**MAJOR PROJECT ASSESSMENT:
ILLAWARRA RIDGE GOLF RESORT
LOTS 2, 3 & 4 DP240566, PORTION 74 &
160 DP752054 AND PORTION 76 DP
104884761, PRINCES HIGHWAY, DARKES
FOREST
Proposed by LINKS ILLAWARRA
DEVELOPMENTS PTY LTD**

Director-General's
Environmental Assessment Report
Section 75I of the
Environmental Planning and Assessment Act 1979

January 2009

Figure 13 - Preferred Project Report (amended concept development layout)

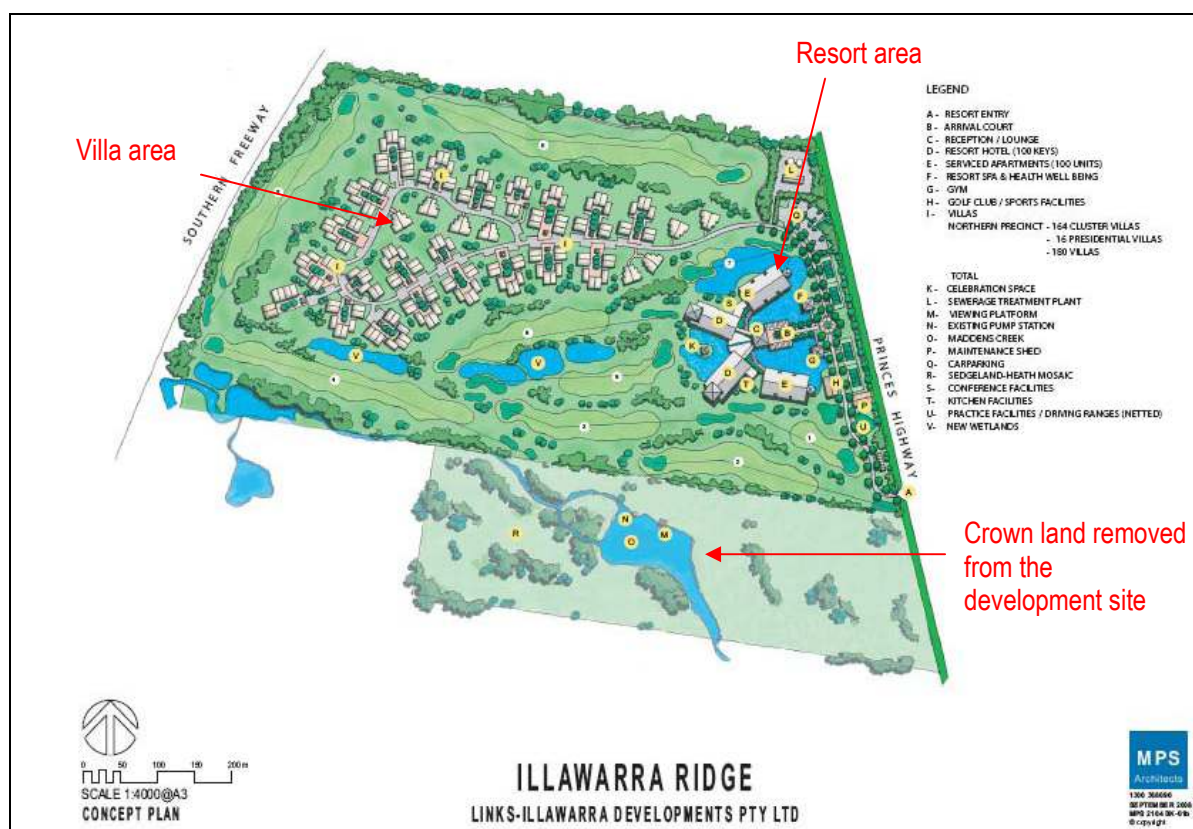
A Preferred Project Report (PPR), submitted on 29 September 2008, incorporated the following amendments to the original Concept Plan (refer to **Figure 13**):

- The southern two lots (Crown land) were removed from the development area. The proposal is now contained entirely within the existing golf course footprint;
- The southern villa precinct comprising 38 villas was removed;
- The density of the central villa precinct increased but there was an overall net reduction of 20 villas from 200 to 180; and
- The proposed access opposite the Boomerang Golf Course has been deleted and the existing entry/exit in the southern portion of the site will be retained.

Figure 17 – Development Layout Showing Restriction Buffers

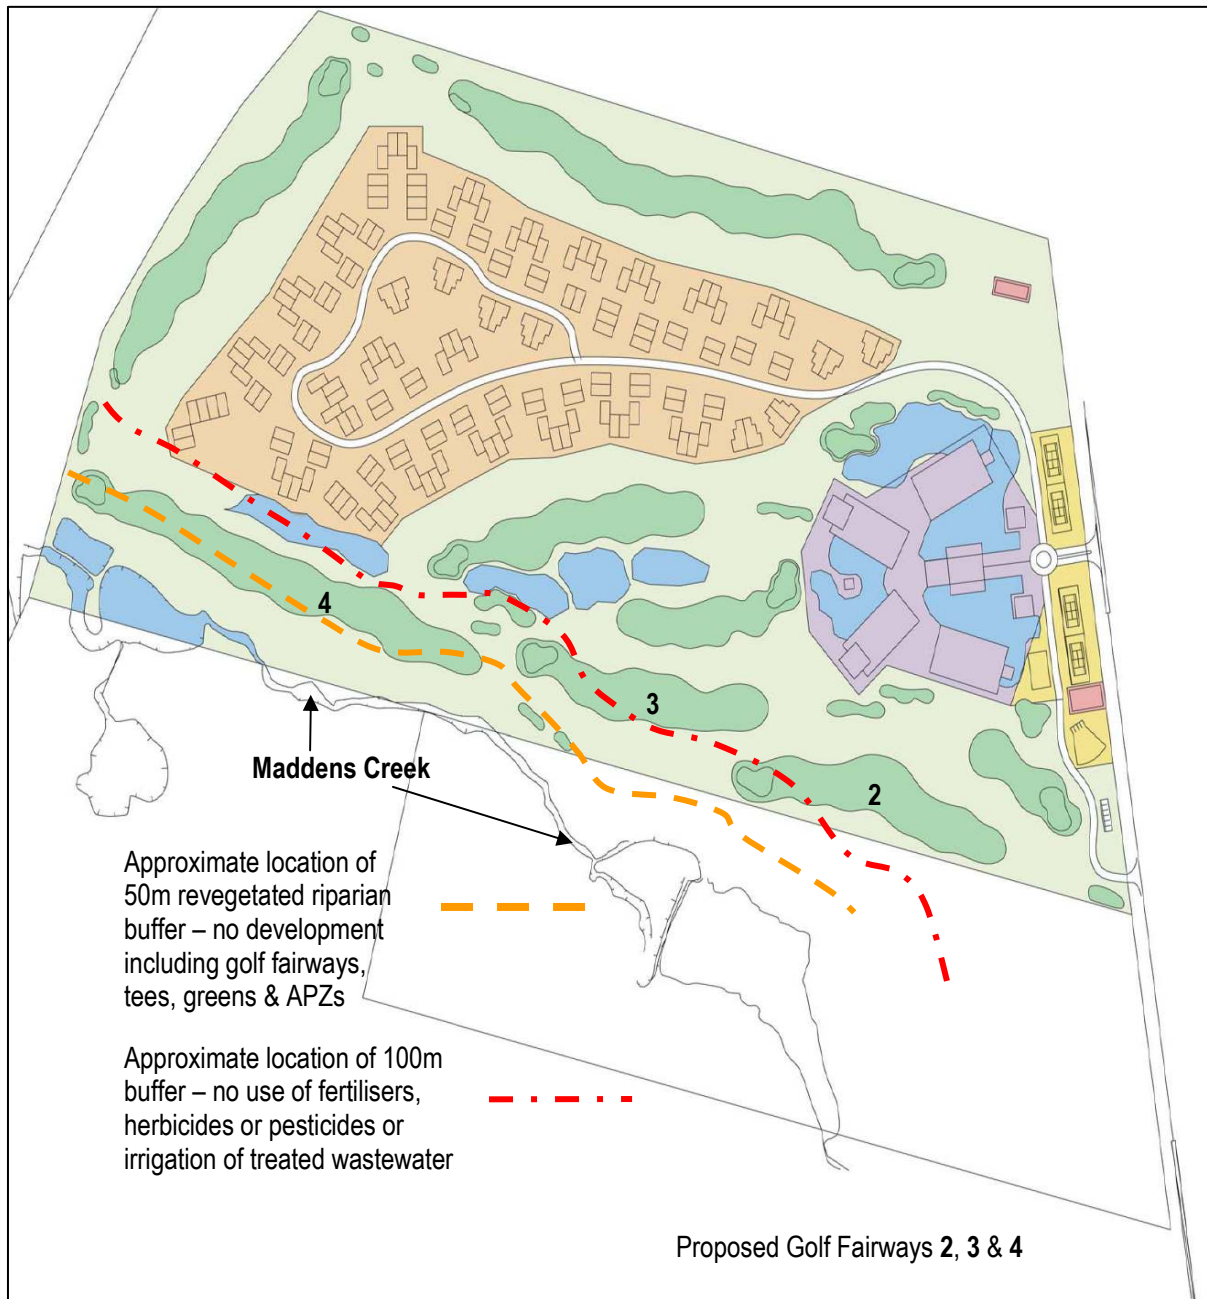
The PPR shows a riparian buffer of 30m on both sides of Maddens Creek. Based on advice from DWE the Department considers that the 30m buffer is not sufficient to ensure the protection of the riparian corridor and that a 50m vegetated buffer should be provided either side of Maddens Creek (refer to **Figure 19**). The riparian corridor along Maddens Creek is well buffered by extensive stands of Ironstone Woodland and Sedgeland Heath to the east. No part of the proposal will extend into the area south of Maddens Creek. The riparian corridor will be established for the protection and enhancement of riparian vegetation and vegetated with local native tree, shrub and groundcover species at a density that would occur naturally.

DWE have raised concern with pollution of groundwater if effluent and stormwater is not adequately treated. The WQCP, prepared by the proponents consultant, SEEC Morse McVey recommends no irrigation of recycled water within 100m of Maddens Creek or 40m for tertiary treated effluent. All wastewater is to be treated to a tertiary level in the Sewerage Treatment Plant. The DWE supports a minimum 100m setback for use of recycled effluent or use of fertilisers from Maddens Creek. It is considered all on-site sewerage must be treated to a tertiary level and applied using subsurface irrigation. The irrigation of effluent on the golf course should be prohibited within 100m of the northern bank of Maddens Creek (i.e. riparian buffer zone).

It is understood that most golf courses only apply fertilisers to the greens and tees otherwise if a fairway is over fertilised and grows too quickly there is significant expense involved in regular mowing and maintenance. The quantity of fertiliser used by a golf course is less than required for cereal production however, most course superintendants seek to maintain a suitable appearance and run for the amenity of golfers. There are alternative fertilisers such as organic fertiliser (fish or seaweed) which could be considered. The Australian Golf Course Superintendents Association (AGCSA) is a leading organisation in best practice environmental management of golf courses across Australia and has been working with EPAR, an organisation that implements Environmental Management Systems for the golf courses. The adoption of an EMS should be considered as part of any future project application for development on the site to ensure sustainable golf course management.

Figure 18 – Modified development layout showing the removal of 53 villas

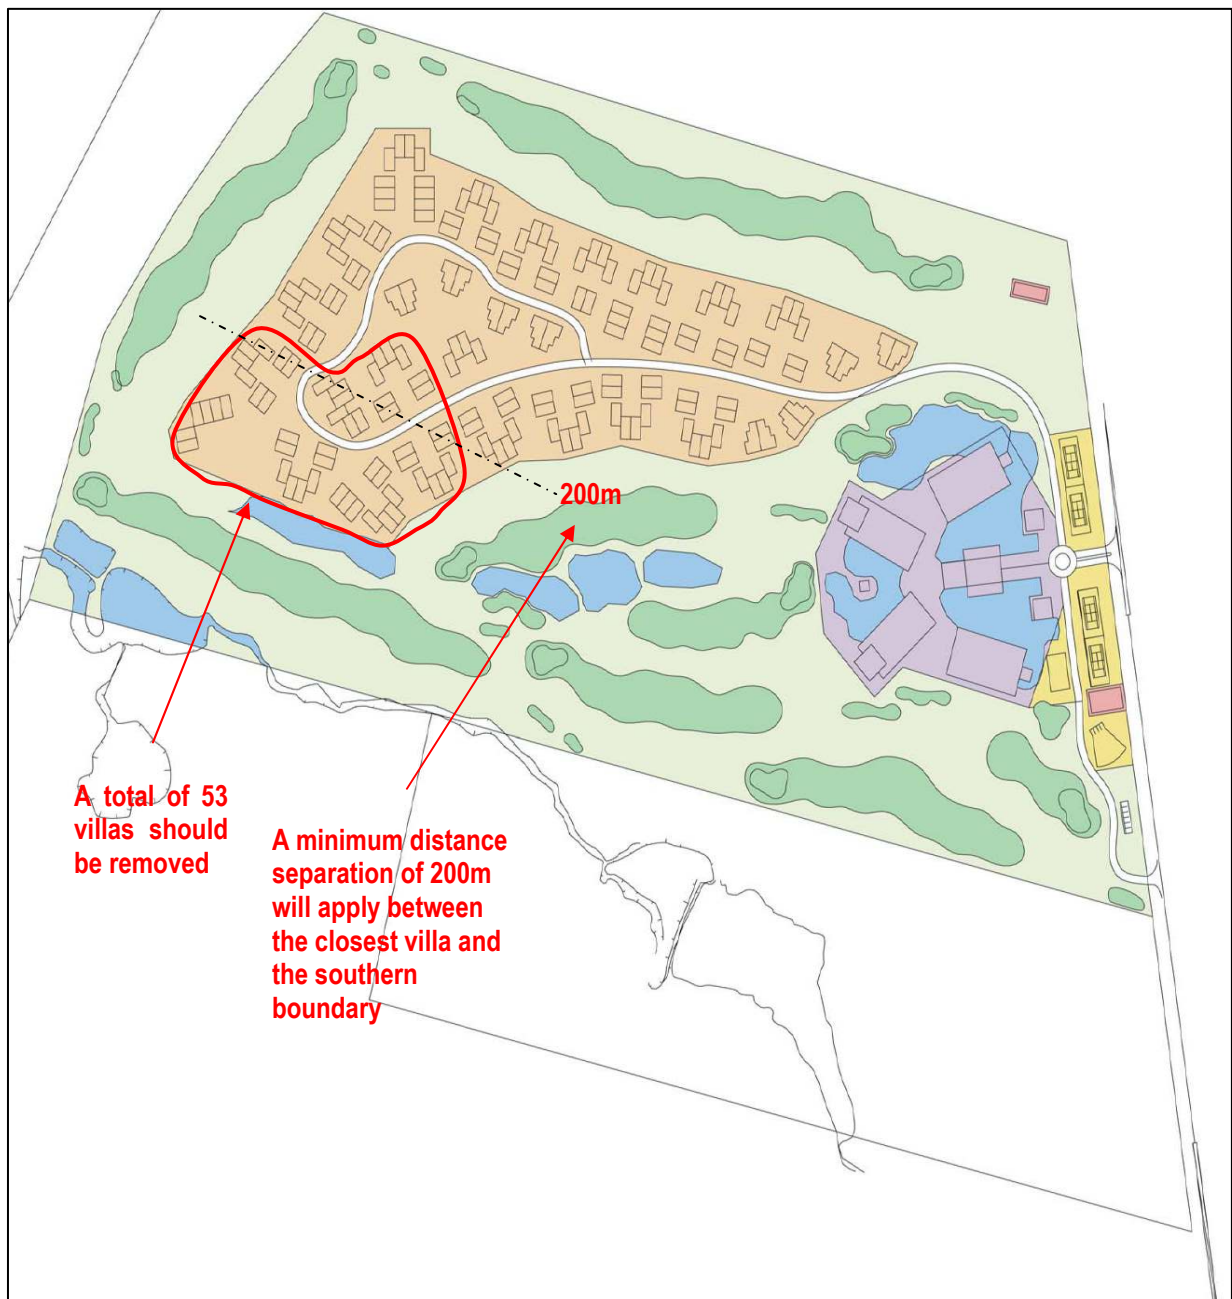
There is no doubt the development will result in an urbanised development and will change the low density rural/open space character of the locality. To minimise the extent of this change, there should be a reduction in the number of villas and a corresponding decrease in the development footprint to provide a better opportunity for spacing and landscaping between buildings to minimise visual impact. A total of 7 of the southernmost clusters should be removed (equating to 53 villas or a 30% reduction) resulting in a total of 127 villas in the central villa precinct (refer to **Figure 18**). This represents a density of about 24 bedrooms per hectare which is less than the maximum density permitted in the Becton central precinct.

- There will be lower wastewater loads and the risk of pollution of Maddens Creek.
- It will allow reconfiguration of the golf fairways to ensure there is no irrigation of treated wastewater within 40m of a Water Quality Control Pond or the north-south drainage line in the south-western part of the site.

- It will result in less hard paved area (eg. roadway) and more permeable area (soft landscaping) and increase rainwater infiltration.
- There is the potential to retain more existing trees in this part of the site.

In order to achieve a satisfactory density of tourist villas the following restrictions are recommended to apply to the central villa tourist precinct:
